Access Compliance Report

Public Rights-of-Way

Intersection ID: 28255	Main Street: REA_RD	Cross Street: ARDREY_KELL_RD	Location: SW
ADA ID: 41E5F5BA7E37	Ramp Type: Perp	Initial Pass/Fail: Fail	Overall Compliance: No
			Severity Score: 21.25

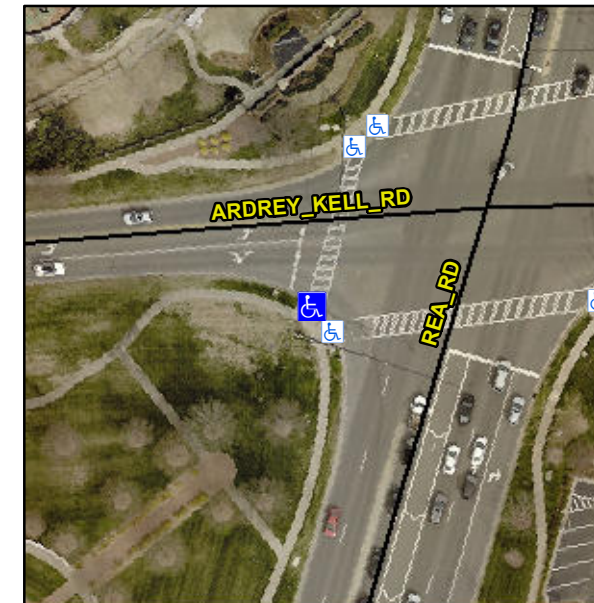
Not Found, R304.5.1, R304.2.2

Compliance	Description	Data	Compliance	Description	Data
N/A	Ramp Length (in)	79.0	No	Ramp Slope (%)	8.9
No	Ramp Width (in)	37.0	Yes	Ramp XSlope (%)	1.2
N/A	Flare Type LT	N/A	N/A	Flare Type RT	N/A
N/A	Flare Slope LT (%)	N/A	N/A	Flare Slope RT (%)	N/A
N/A	Flare Traversable LT?	N/A	N/A	Flare Traversable RT?	N/A
N/A	Landing Length (in)	N/A	N/A	DWS Provided?	N/A
N/A	Landing Width (in)	N/A	N/A	DWS Contrast?	N/A
N/A	Landing Slope (%)	N/A	N/A	DWS Length (in)	N/A
N/A	Landing X Slope (%)	N/A	N/A	DWS Full Width?	N/A
N/A	Landing Curb? (Y/N)	N/A	N/A	DWS Offset (in)	N/A
N/A	Shared Landing?	N/A			
N/A	Gutter Ponding?	N/A	N/A	Gutter Slope (%)	N/A
N/A	Gutter Lip Ht (in)	3.0	N/A	Gutter X Slope (%)	N/A
N/A	Painted X Walk1?	Yes	N/A	Painted X Walk2?	N/A
	X Walk 1 Direction	To NE		X Walk 2 Direction	N/A
N/A	X Walk 1 Width (in)	101.0	N/A	X Walk 2 Width (in)	N/A
	X Walk 1 Slope (%)	3.1		X Walk 2 Slope (%)	N/A
	X Walk 1 X Slope (%)	3.3		X Walk 2 X Slope (%)	N/A

Remove & Replace Entire Ramp.
